Access Compliance Report

Public Rights-of-Way

(Curb Ramps)

Intersection ID: 52790	Main Street: COLEMON_KERRY_DR	Cross Street: FRIENDSHIP_VILLAGE_PL	Location: SW
ADA ID: E7A5199389B2	Ramp Type: Perp	Initial Pass/Fail: Fail	Overall Compliance: No
Severity Score: 21.25			
Codes/Mitigation Info/Possible Solution		Field Measurements/Component Compliance

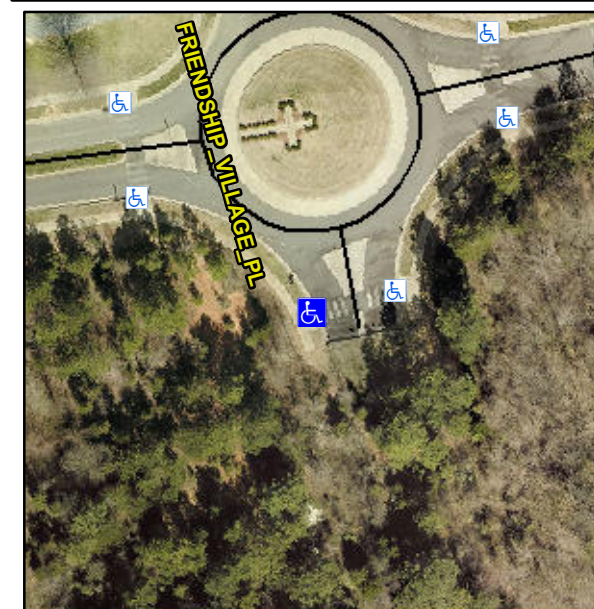
Not Found, R304.5.1, R304.2.2

Compliance	Description	Data	Compliance	Description	Data
N/A	Ramp Length (in)	73.5	No	Ramp Slope (%)	8.6
No	Ramp Width (in)	47.0	Yes	Ramp XSlope (%)	0.1
N/A	Flare Type LT	N/A	N/A	Flare Type RT	N/A
N/A	Flare Slope LT (%)	N/A	N/A	Flare Slope RT (%)	N/A
N/A	Flare Traversable LT?	N/A	N/A	Flare Traversable RT?	N/A
N/A	Landing Length (in)	N/A	N/A	DWS Provided?	N/A
N/A	Landing Width (in)	N/A	N/A	DWS Contrast?	N/A
N/A	Landing Slope (%)	N/A	N/A	DWS Length (in)	N/A
N/A	Landing X Slope (%)	N/A	N/A	DWS Full Width?	N/A
N/A	Landing Curb? (Y/N)	N/A	N/A	DWS Offset (in)	N/A
N/A	Shared Landing?	N/A			
N/A	Gutter Ponding?	N/A	N/A	Gutter Slope (%)	N/A
N/A	Gutter Lip Ht (in)	N/A	N/A	Gutter X Slope (%)	N/A
N/A	Painted X Walk1?	No	N/A	Painted X Walk2?	N/A
	X Walk 1 Direction	To E		X Walk 2 Direction	N/A
N/A	X Walk 1 Width (in)	N/A	N/A	X Walk 2 Width (in)	N/A
	X Walk 1 Slope (%)	3.1		X Walk 2 Slope (%)	N/A
	X Walk 1 X Slope (%)	1.0		X Walk 2 X Slope (%)	N/A

Remove & Replace Entire Ramp.
